WILLIAMSON COUNTY, TEXAS

CHANGE ORDER NUMBER: 5

Project Name: East Wilco Highway Segment 2 Phase 1

3. County Convenience 3L: Revising safety work/measures desired by the County: Due to safety concerns at the newly constructed intersection, Williamson County has requested the installation of traffic signals as part of this project. This Change Order provides for the cost of temporary trailer-mounted signals to be utilized until the design and construction of permanent signals are completed.

TEMPORARY PORTABLE TRAFFIC SIGNALS

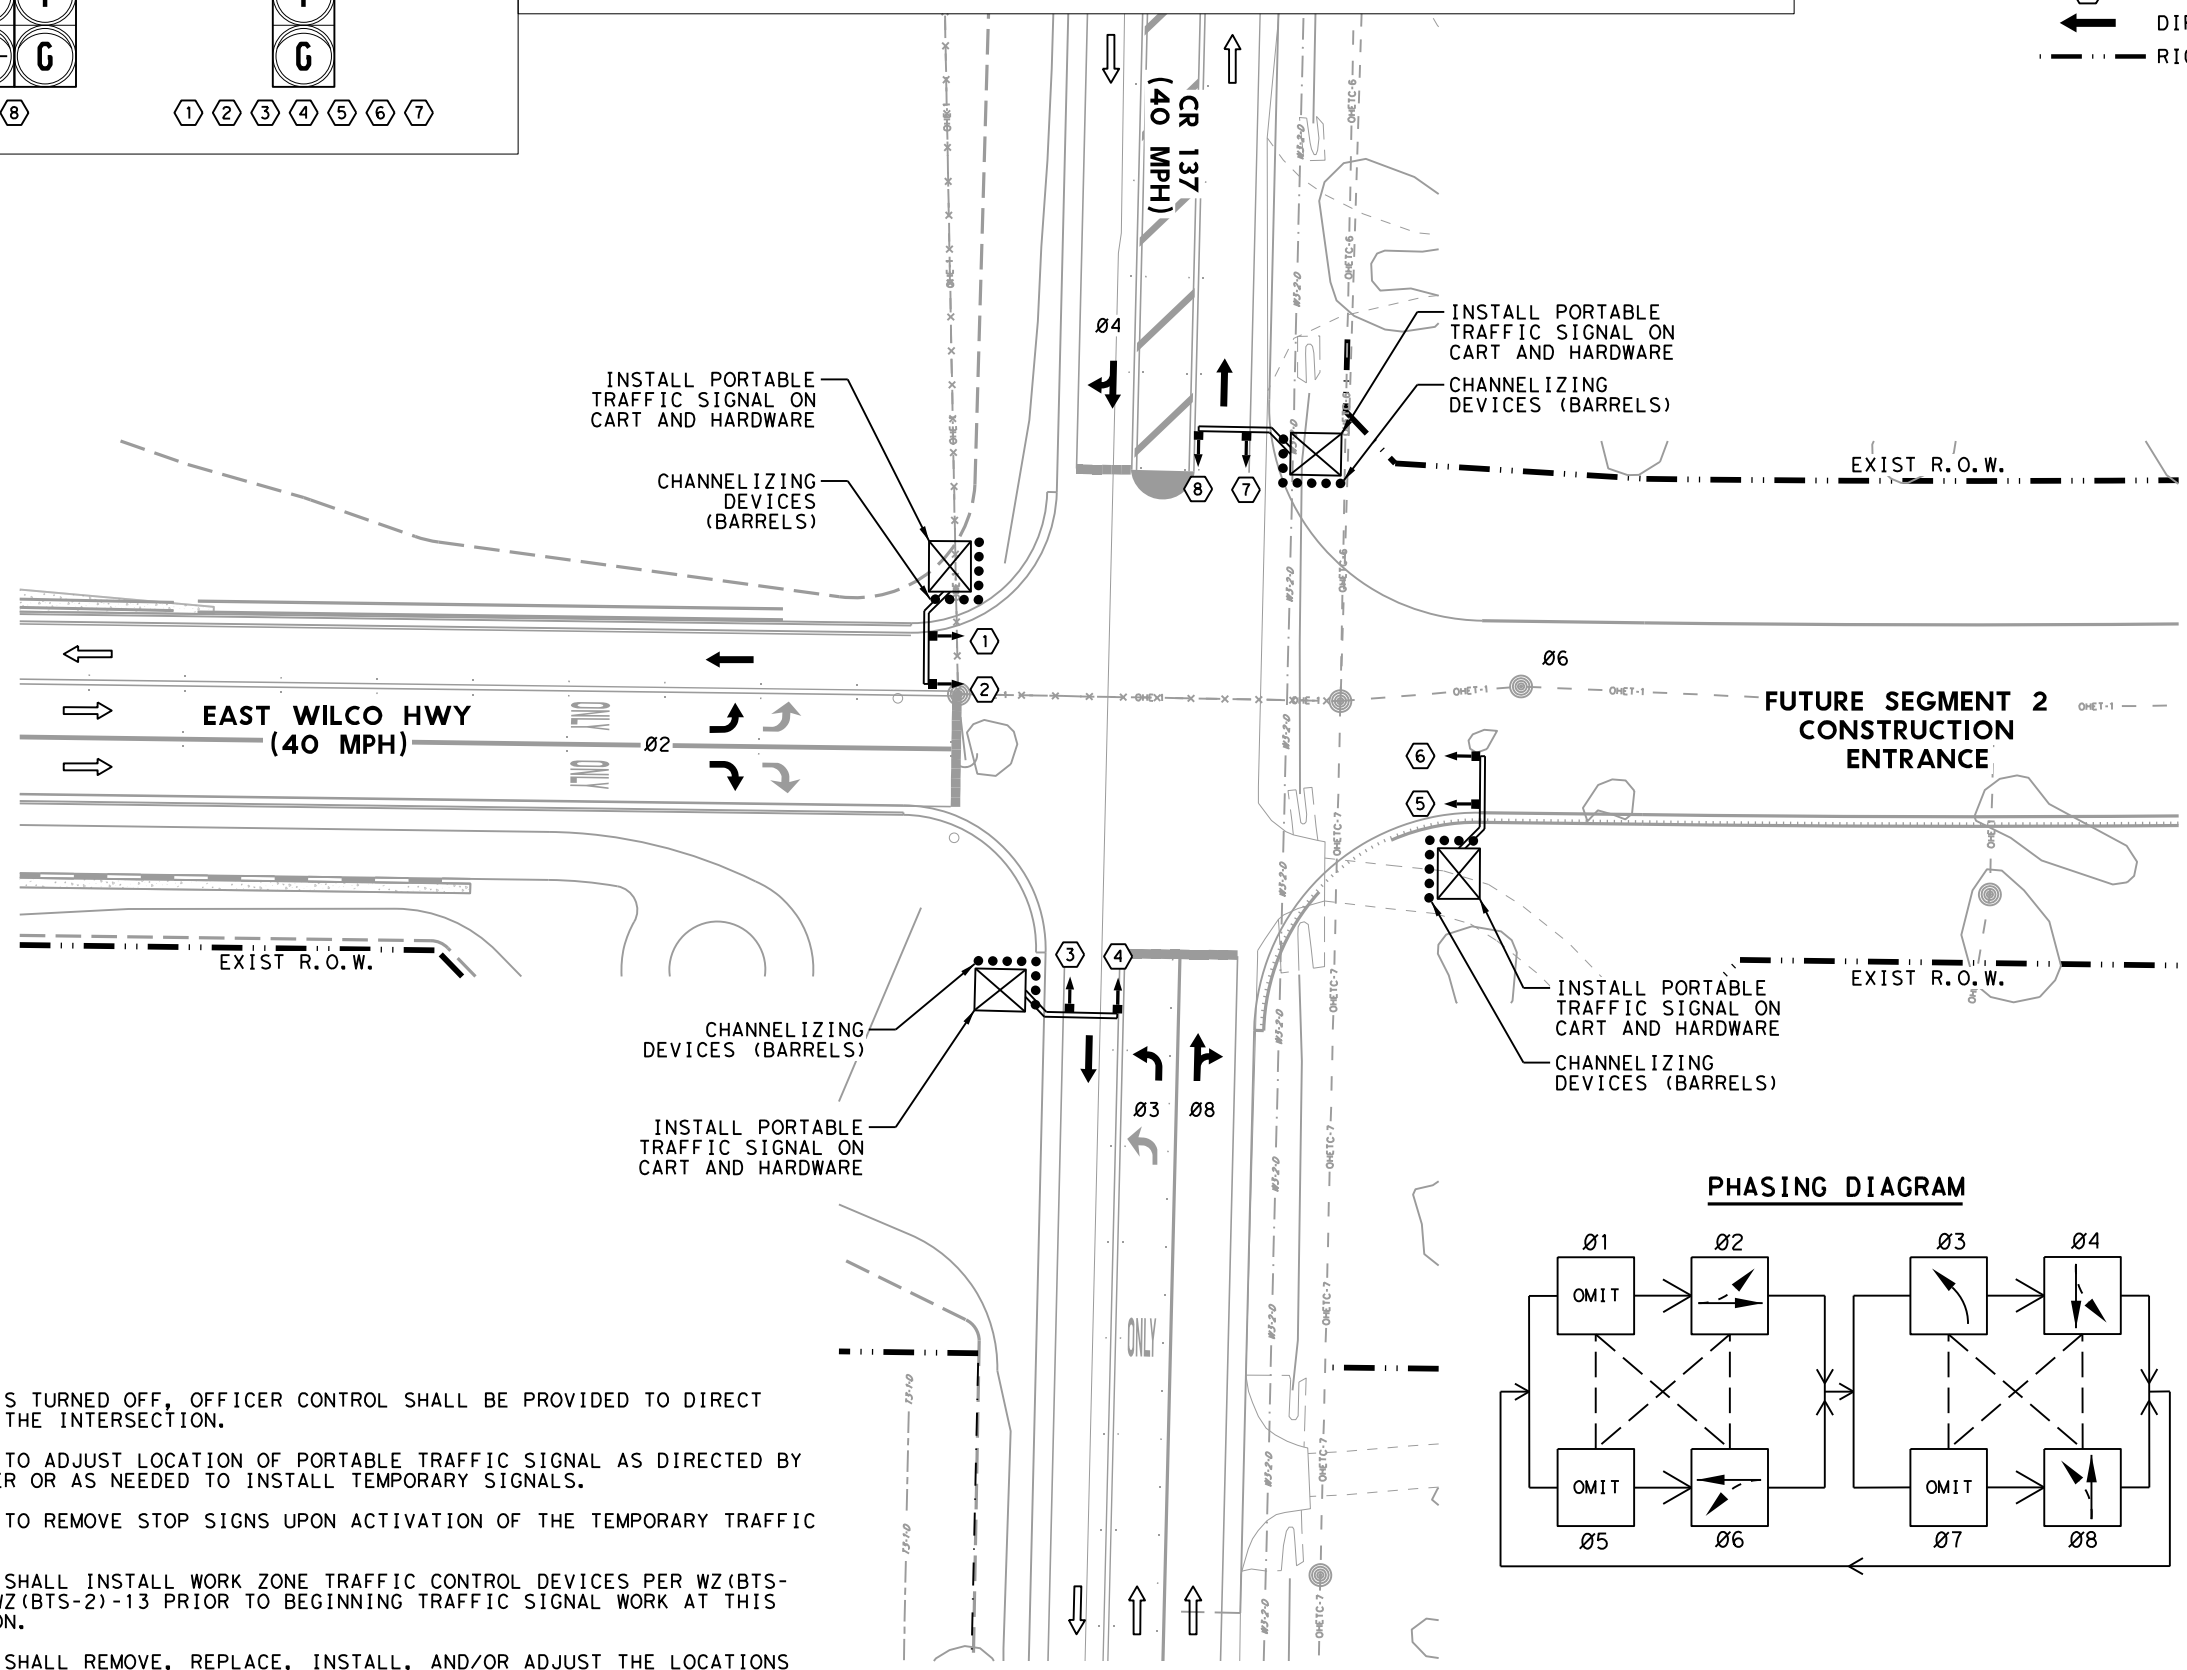
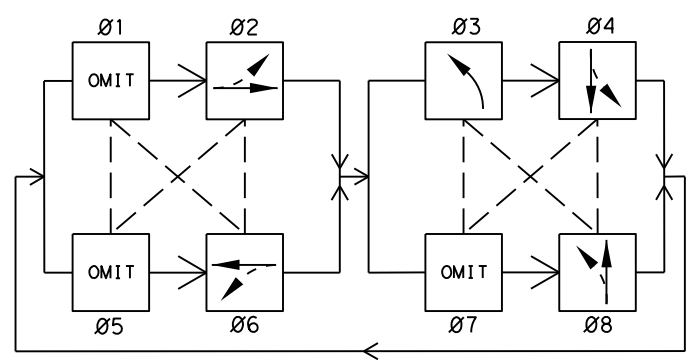
1. TWO PORTABLE CHANGEABLE MESSAGE SIGNS (PCMS) TO BE INSTALLED APPROXIMATELY 1150FT IN ADVANCE FROM NORTHBOUND AND 700FT IN ADVANCE FROM SOUTHBOUND APPROACH STOP-BAR.
2. PORTABLE CHANGEABLE MESSAGE SIGN TO READ "TRAFFIC SIGNAL AHEAD PREPARE TO STOP".
3. PORTABLE CHANGEABLE MESSAGE SIGN TO REMAIN IN USE FROM TIME THAT TRAILER MOUNTED SIGNALS ARE ACTIVATED UNTIL AFTER COMPLETION OF PERMANENT TRAFFIC SIGNAL.

1. IF SIGNAL IS TURNED OFF, OFFICER CONTROL SHALL BE PROVIDED TO DIRECT TRAFFIC AT THE INTERSECTION.
2. CONTRACTOR TO ADJUST LOCATION OF PORTABLE TRAFFIC SIGNAL AS DIRECTED BY THE ENGINEER OR AS NEEDED TO INSTALL TEMPORARY SIGNALS.
3. CONTRACTOR TO REMOVE STOP SIGNS UPON ACTIVATION OF THE TEMPORARY TRAFFIC SIGNAL.
4. CONTRACTOR SHALL INSTALL WORK ZONE TRAFFIC CONTROL DEVICES PER WZ(BTS-1)-13 AND WZ(BTS-2)-13 PRIOR TO BEGINNING TRAFFIC SIGNAL WORK AT THIS INTERSECTION.
5. CONTRACTOR SHALL REMOVE, REPLACE, INSTALL, AND/OR ADJUST THE LOCATIONS OF STOP BAR PAVEMENT MARKINGS AS DIRECTED BY THE ENGINEER.

PROPOSED SIGNING & PAVEMENT MARKINGS LAYOUT

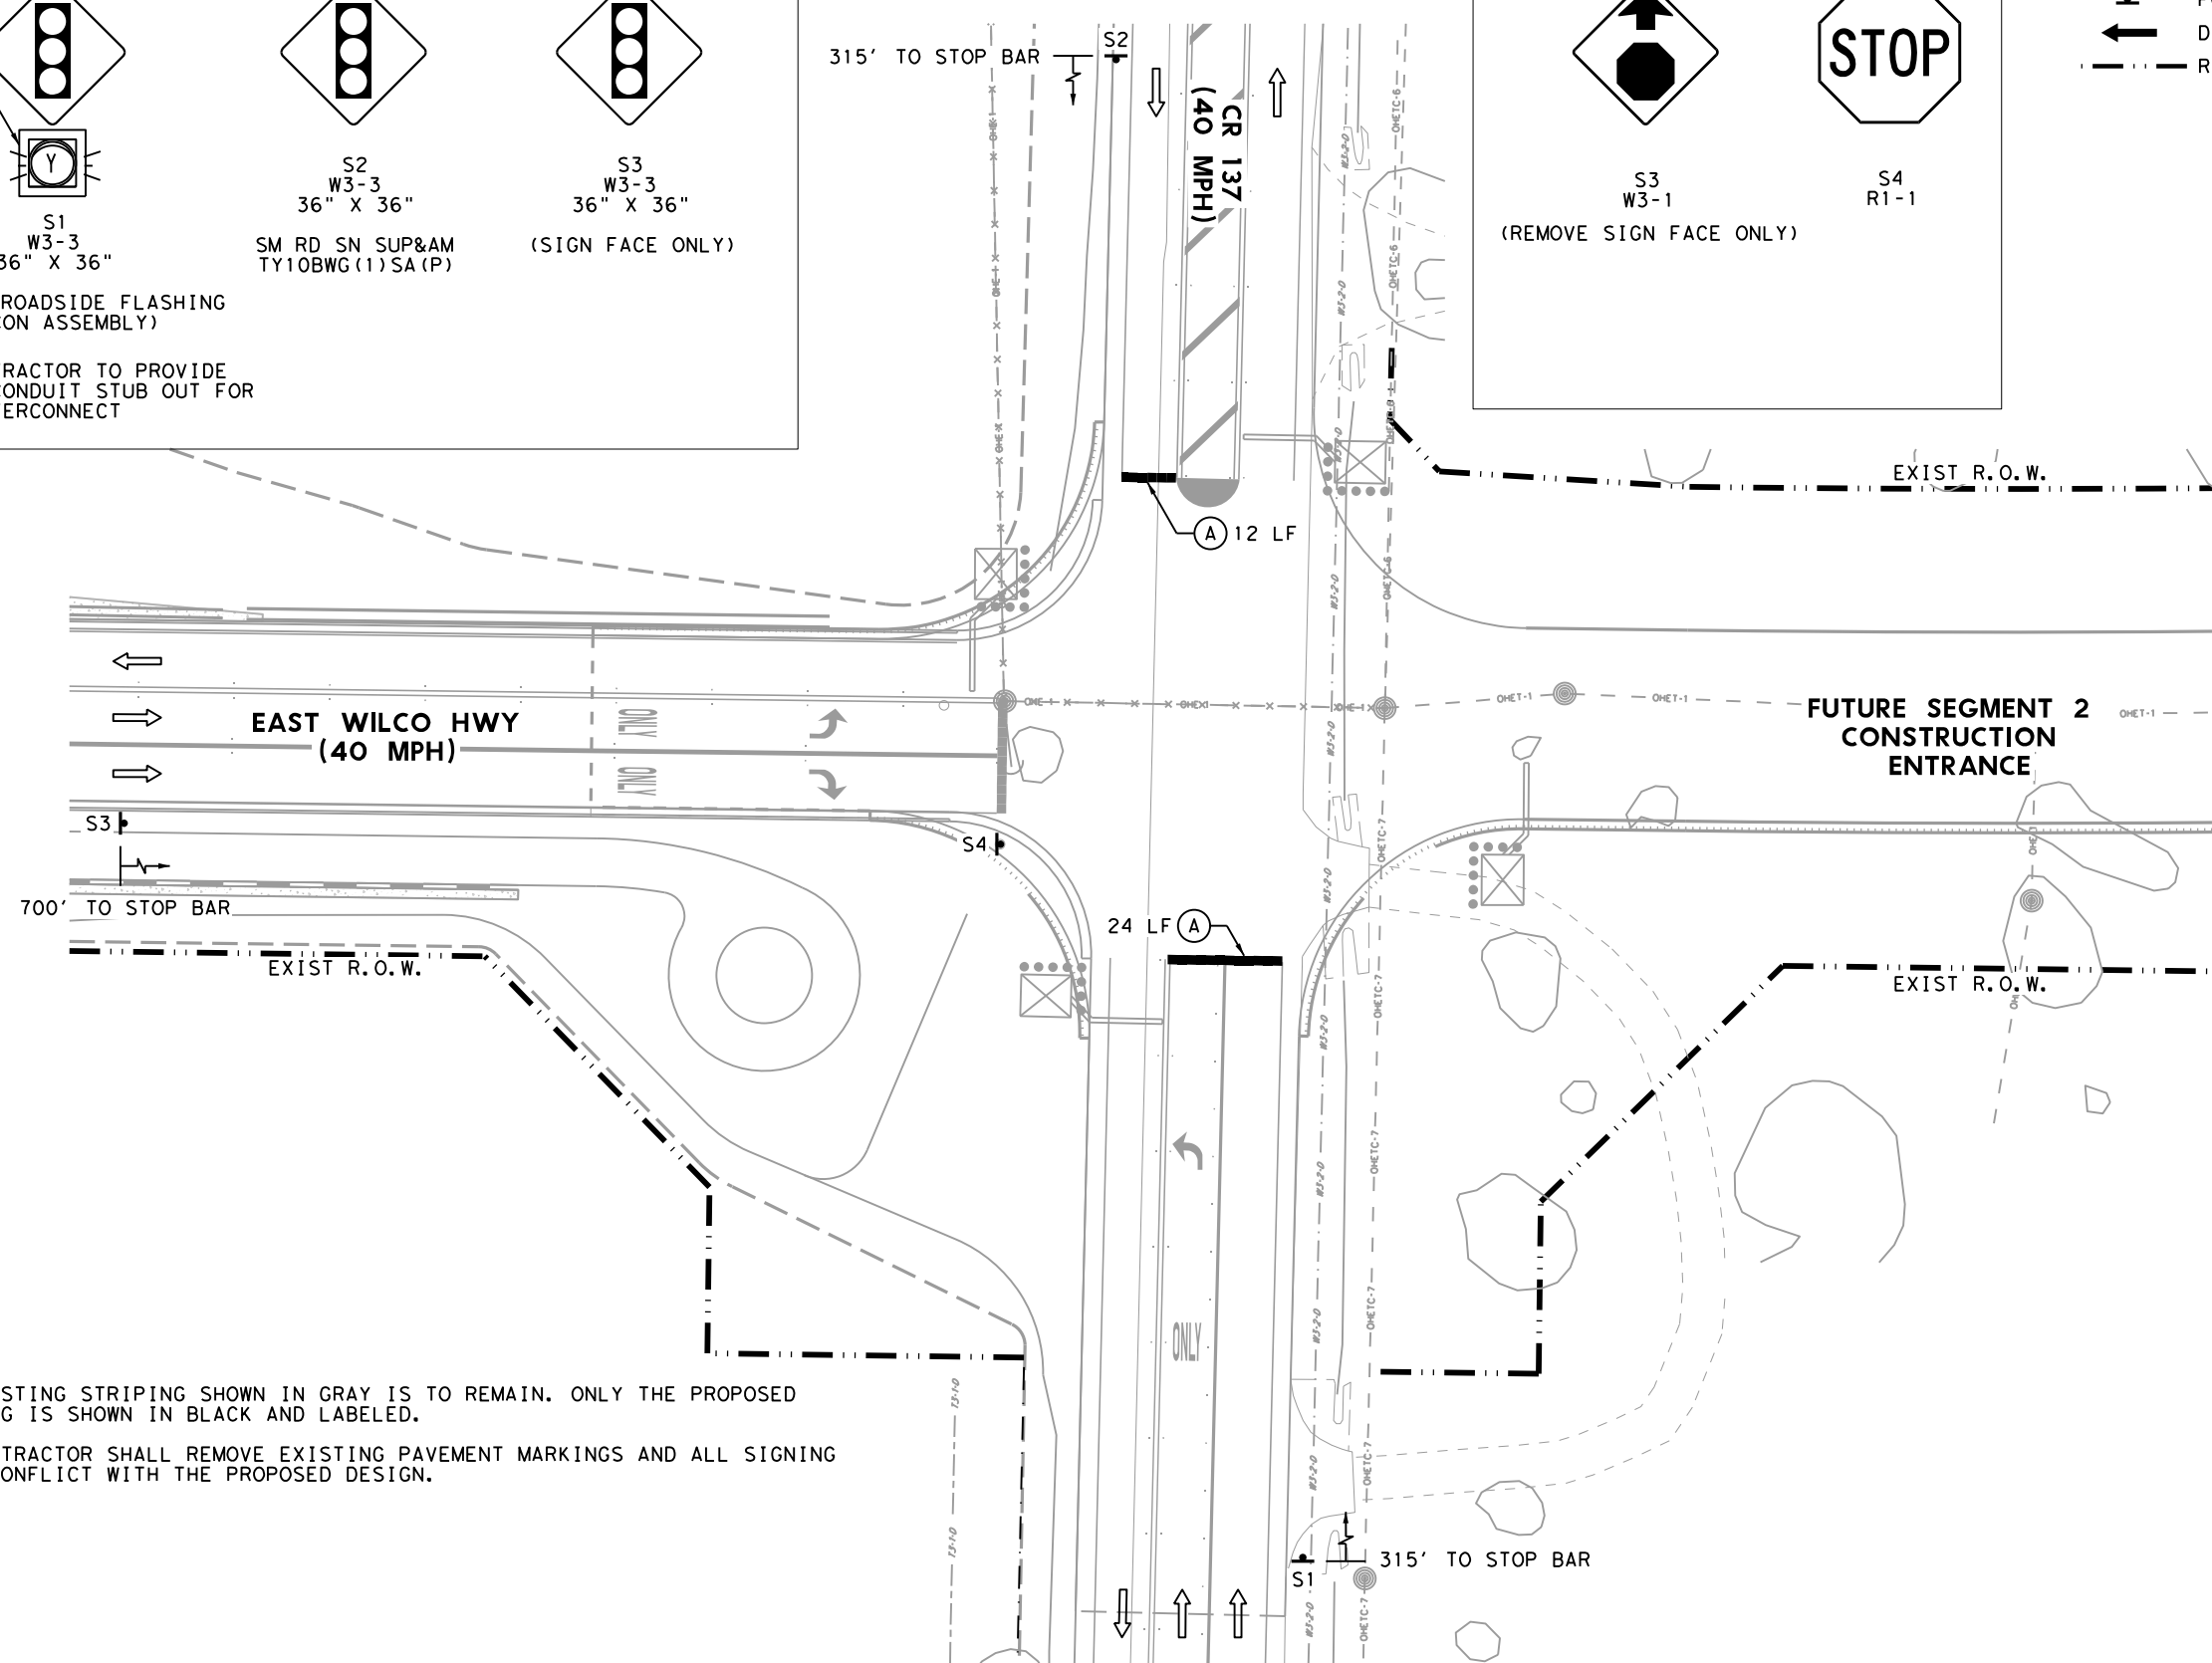
- ### NOTES:
1. THE EXISTING STRIPING SHOWN IN GRAY IS TO REMAIN. ONLY THE PROPOSED STRIPING IS SHOWN IN BLACK AND LABELED.
 2. THE CONTRACTOR SHALL REMOVE EXISTING PAVEMENT MARKINGS AND ALL SIGNING WHICH CONFLICT WITH THE PROPOSED DESIGN.
